BRANDON AVENUE COMMERCIAL CENTER

GRADING PLAN 1

City of Roanoke
Planning, Building, & Development
COMPREHENSIVE DEVELOPMENT PLAN
FIELD REVISION APPROVED
by Ken Richardson
04/26/2023

C5.1

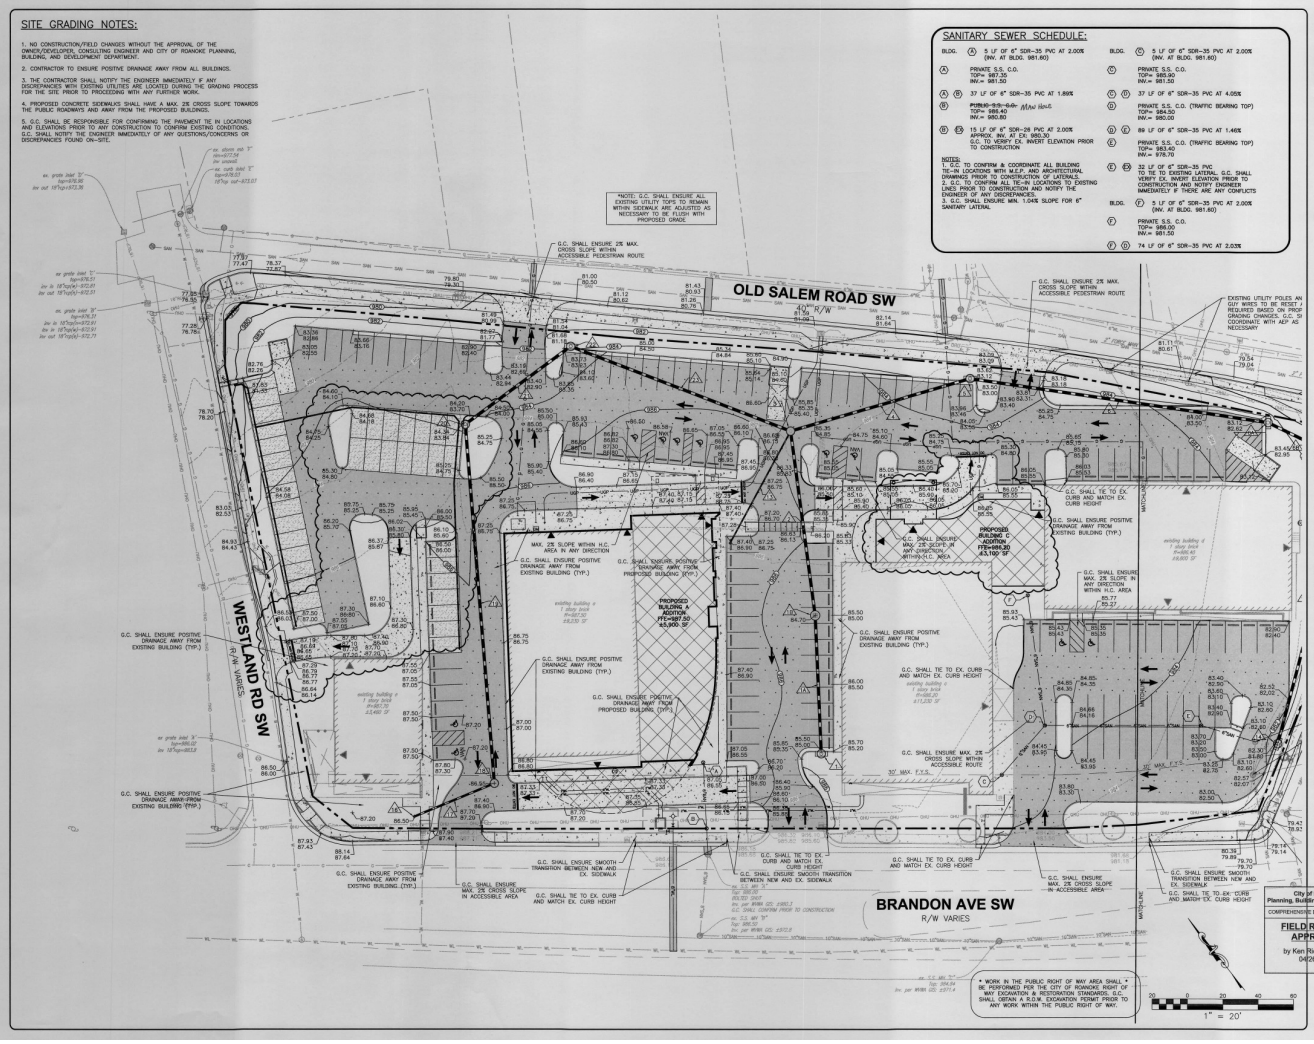
(B) ~~PRIVATE S.S. C.O. TOP= 986.40 INV.= 980.80~~ Also labeled.
